THE CLEVELAND ELECTRIC ILLUMINATING COMPANY

PY-CEI/NRR-0010 L

Perry Nuclear Power Plant
Bracket Nos. 50-440; 50-441
SER Outstanding Issue No. 9
Pool Dynamic Loads

APPENDIX 3B
CONTAINMENT LOADS

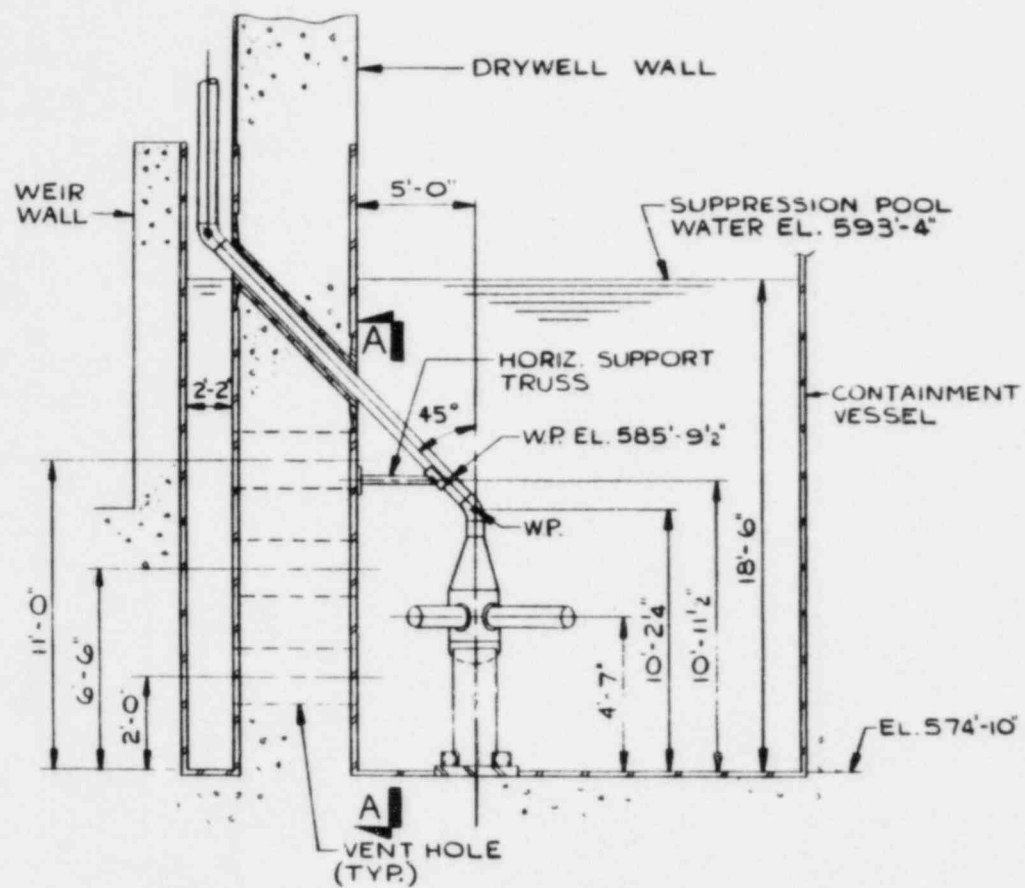
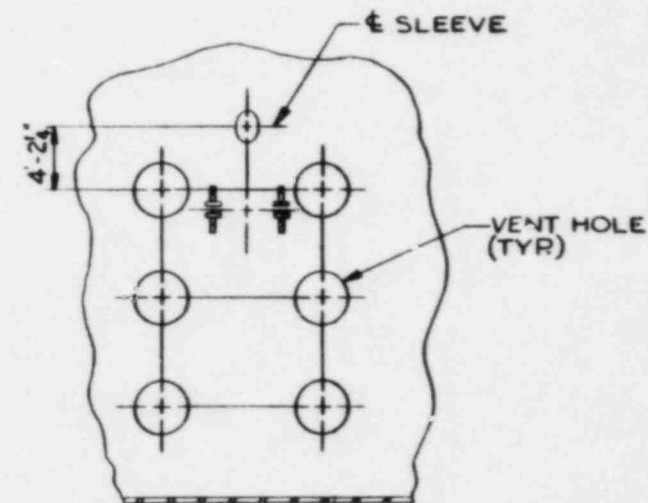
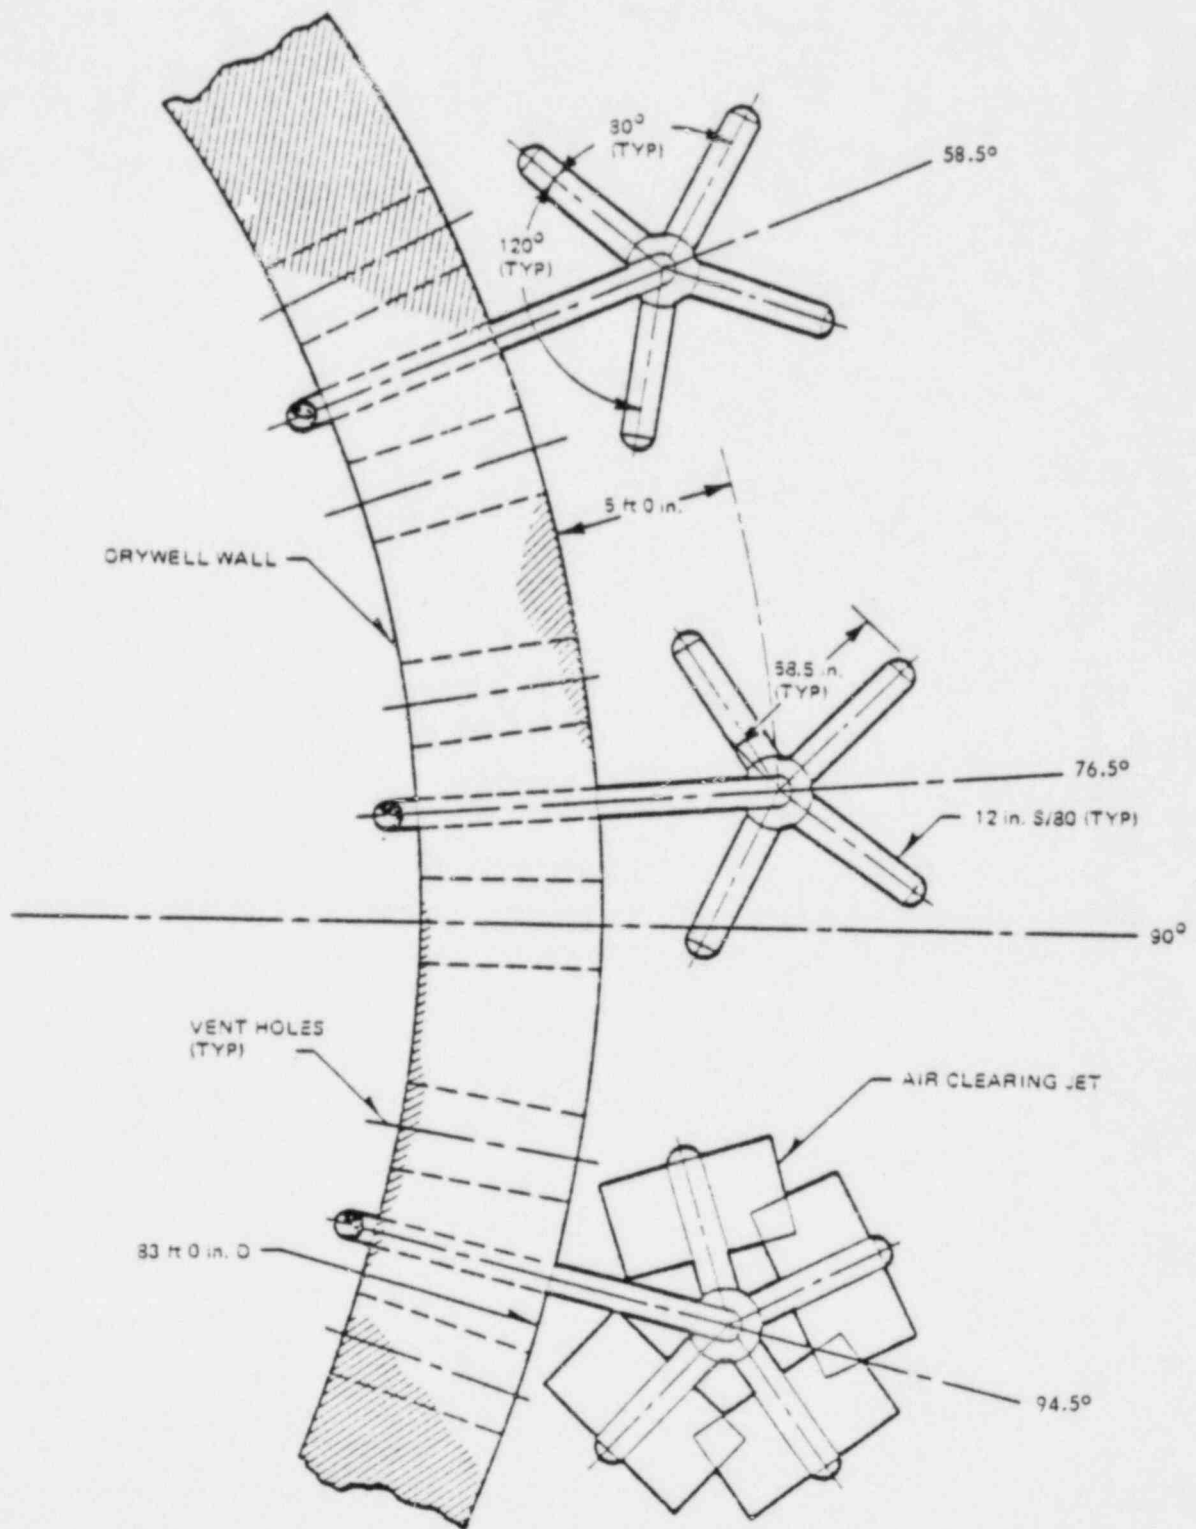
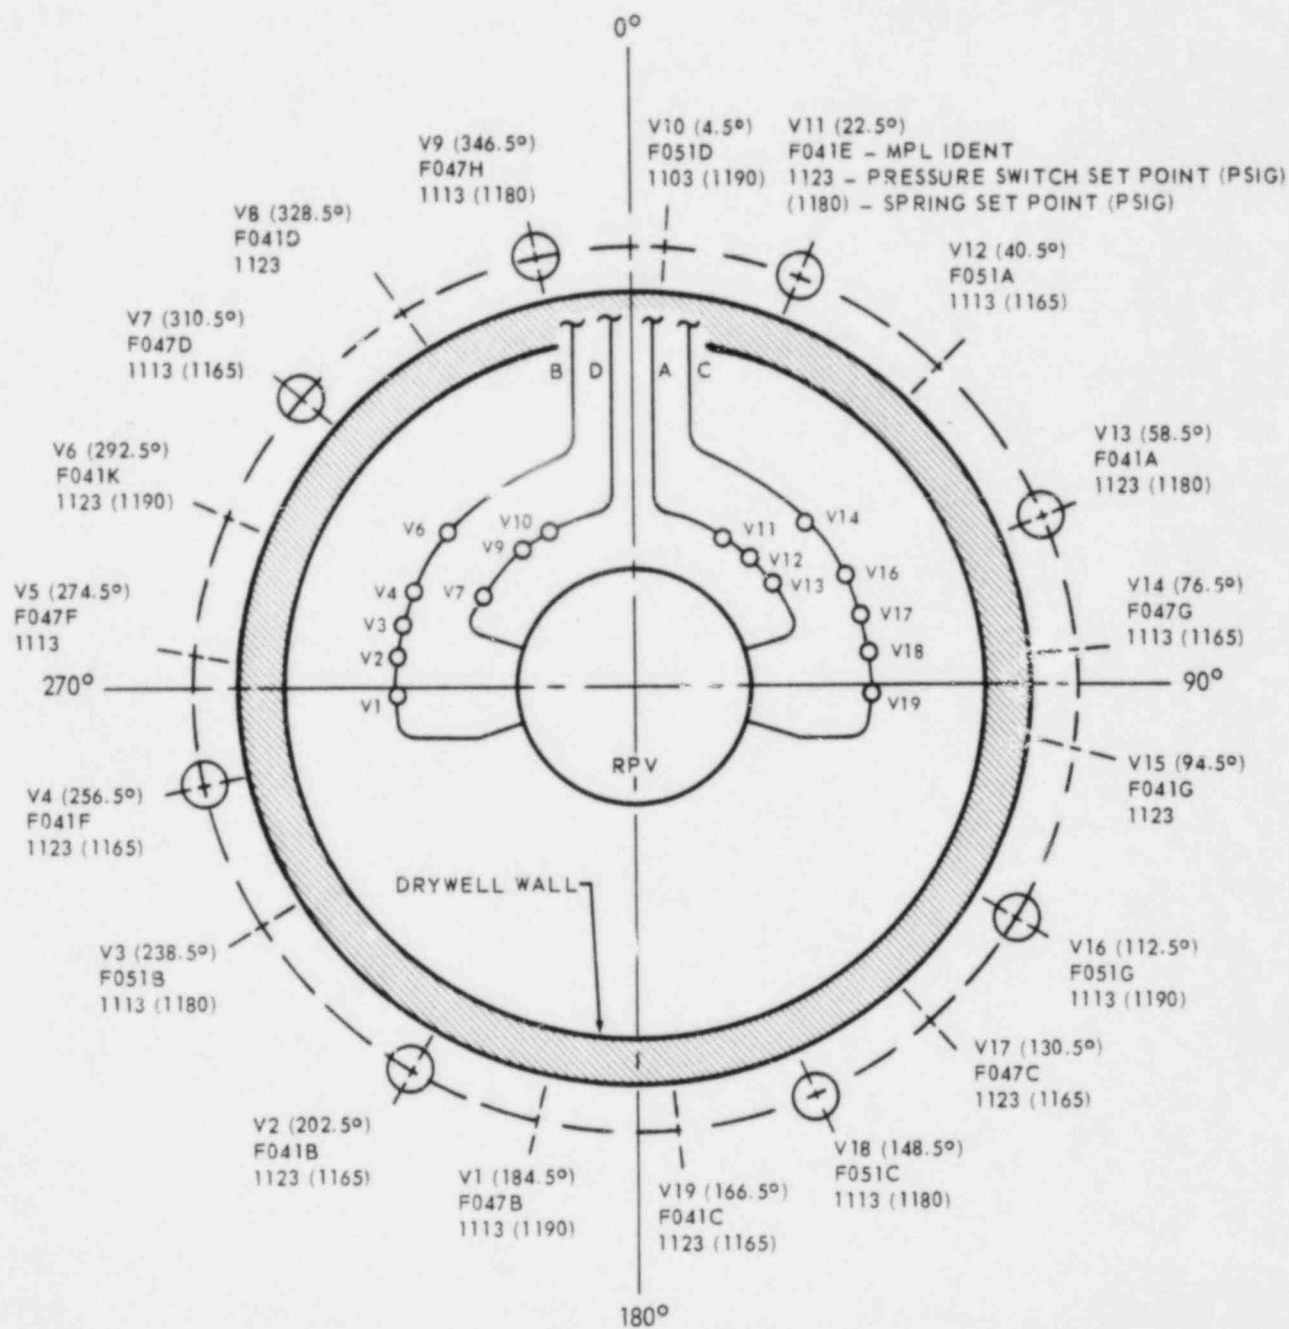
CESSAR Figures 3BA-2 through 3BA-4 are not applicable to Perry. Perry FSAR Figures A-1, A-2 and A-3 (located in this attachment) show the elevation and plan views of the Perry quencher arrangement.

GESSAR Figures 3BA-2 through 3BA-6 and 3BA-28 and Tables 3BA-13 and 3BA-14 are not applicable to Perry. FSAR Figures A-1, A-2 and A-3 show the general arrangement of the quenchers in the pool. The quencher anchor loads are defined in Table A-3 and Table A-4.

FSAR Figures A-1, A-2, and A-3 show the quencher side elevation, top elevation and angular locations in the suppression pool. GESSAR Figures 3BA-2, 3BA-3 and 3BA-4 are not applicable to Perry.

FIGURE A-4

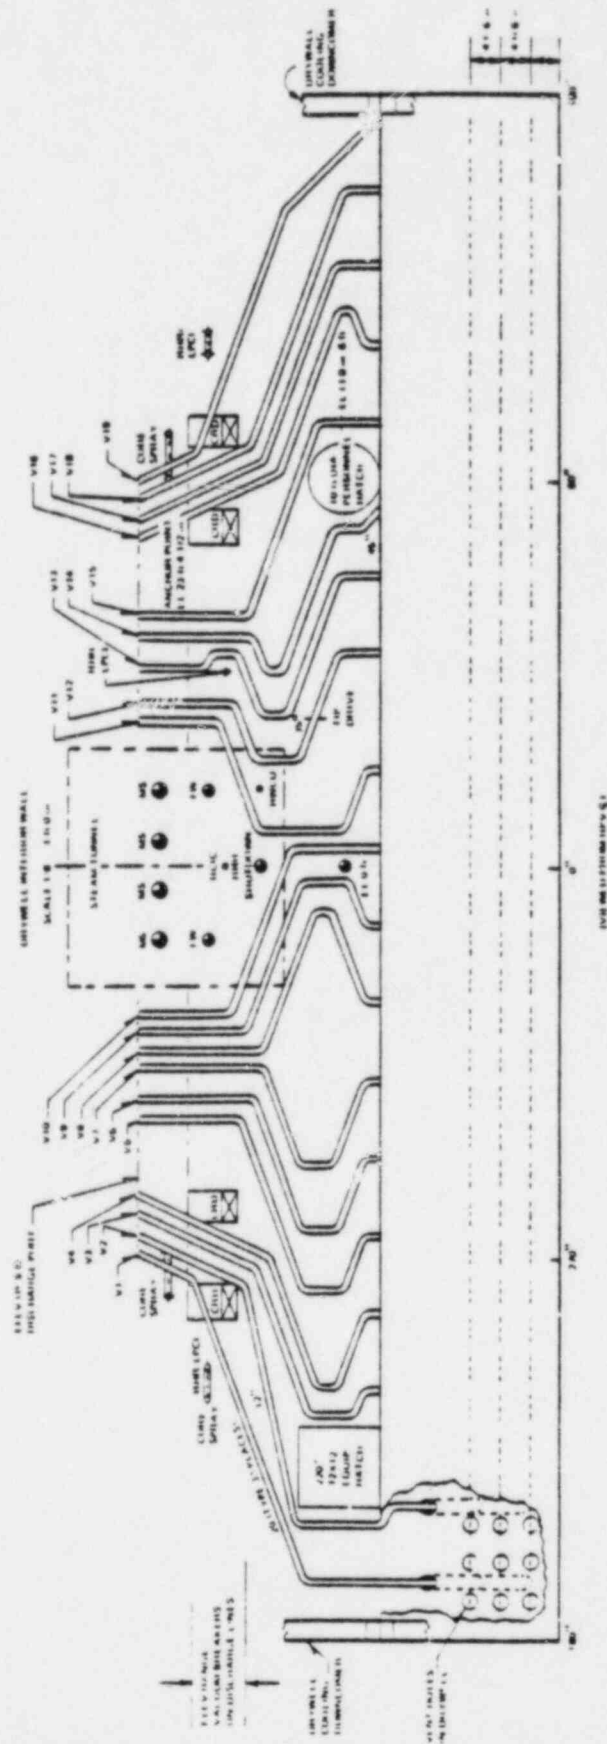
CESSAR Figure 3BA-7 is not applicable to Perry. FSAR Figure A-4 shows the SRVDL routing for Perry.

CESSAR Table 3BA-1 and CESSAR Figure 3BA-7 are not applicable to Perry. FSAR Table A-1 shows Perry SRVDL line lengths and volumes based on the Perry SRVDL layout shown in FSAR Figure A-4.

FIGURE A-5

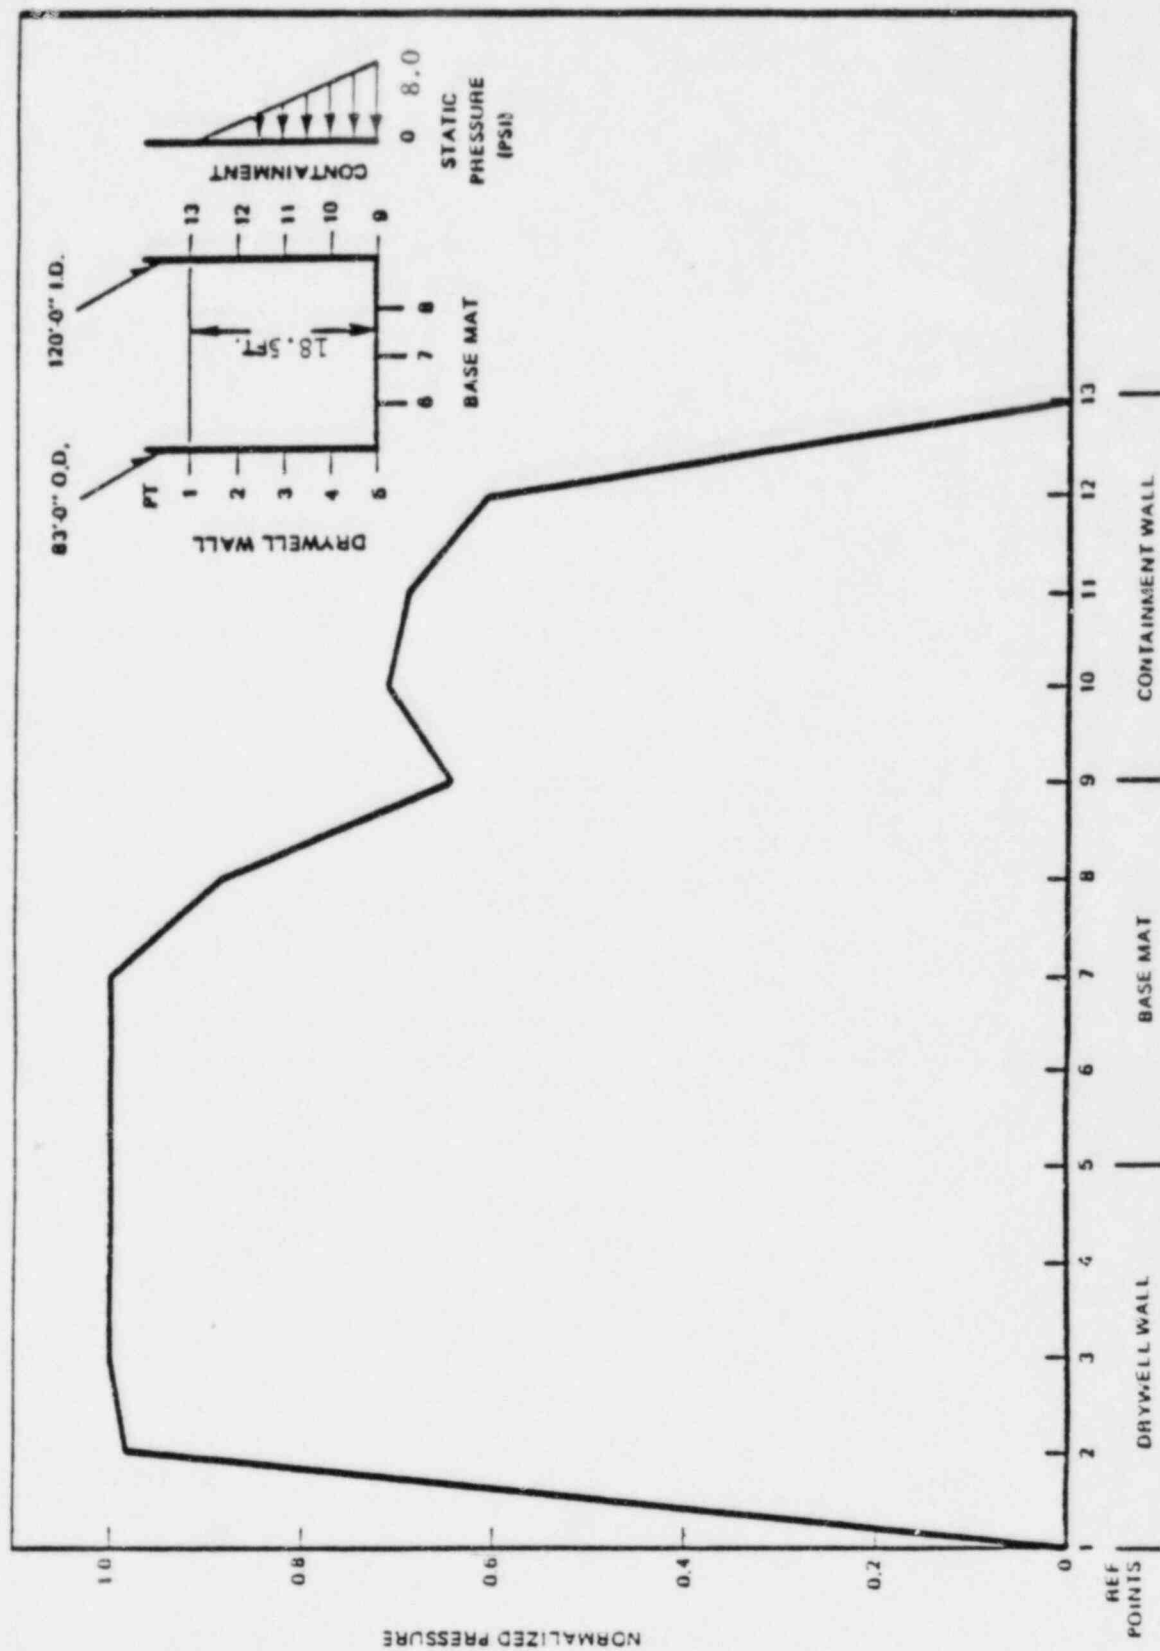
CESSAR Table 3BA-6 and Figure 3BA-8 are not applicable to Perry. FSAR Table A-3 and Figure A-5 show Perry design values.

FIGURE A-6

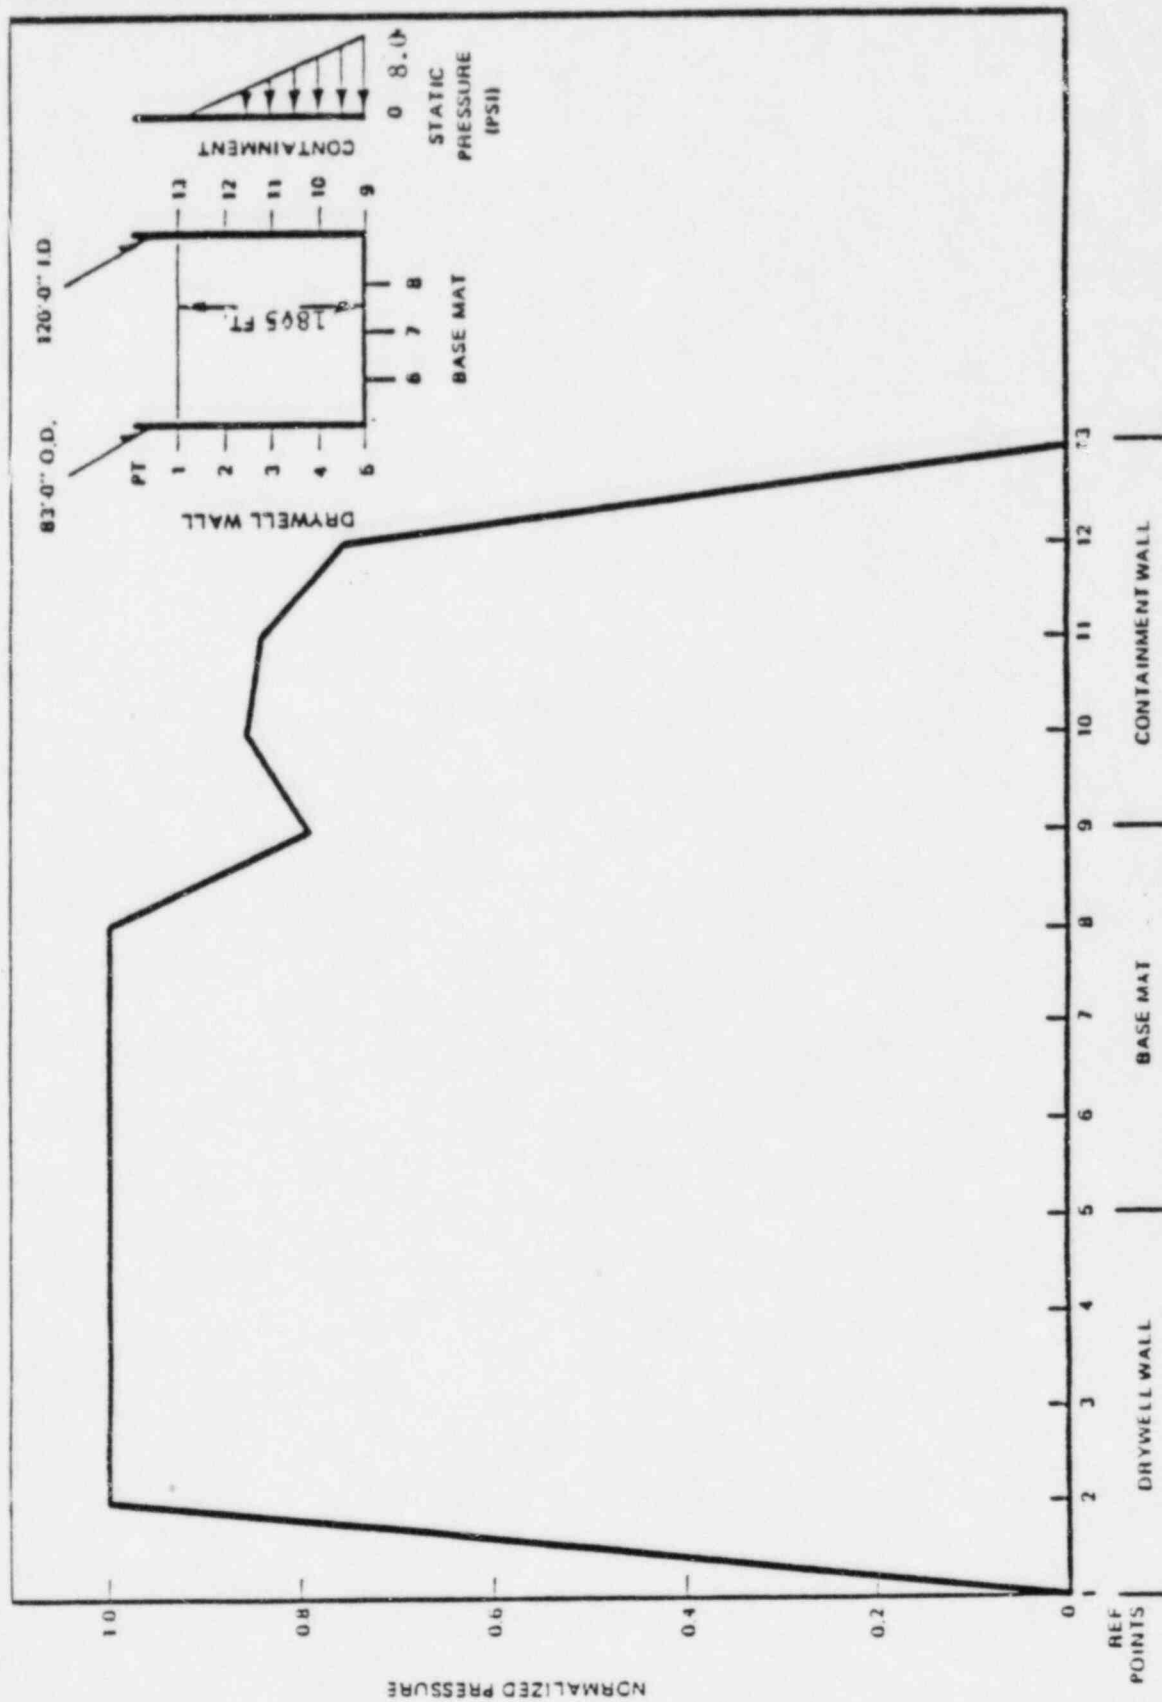
CESSAR Table 3BA-7 and Figure 3BA-11 is not applicable to Perry. FSAR Table A-4 and Figure A-6 show Perry design values.
